SITE PLAN REVIEW AND APPEARANCE BOARD MEMORANDUM STAFF REPORT

Martini Property

The action before the Board is to consider the Class V Site Plan and Landscape Plan for a parking area and cross access easement for the Martini Property associated with the Fourth and Fifth Delray (iPic Movie Theater) project.

Martini Property - Class V Site Plan and Landscape Plan With The

59 S.E. 4th AVENUE DELRAY BEACH, FL TREE REMOVAL PLAN

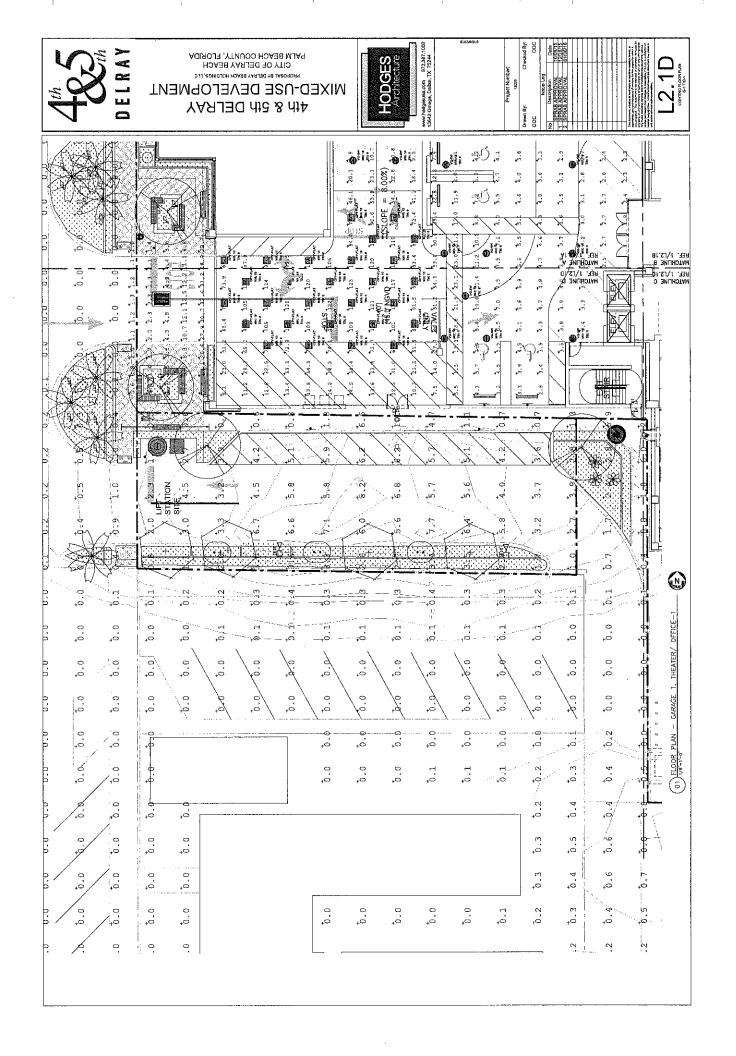
1. Tree #'s 1 -3 (city-owned Foxtail Palms) and #'s 6-7 (Sabal Palms) shall be saved either onsite or off-site. Update the Existing Tree Disposition plan to show final locations for all relocated trees. Provide a separate column entitled "Relocated To". Trees will either be relocated on-site or off-site. If off-site, provide an asterisk next to each tree with a note. The note shall read, "All trees to be relocated off-site shall be coordinated with the City of Delray
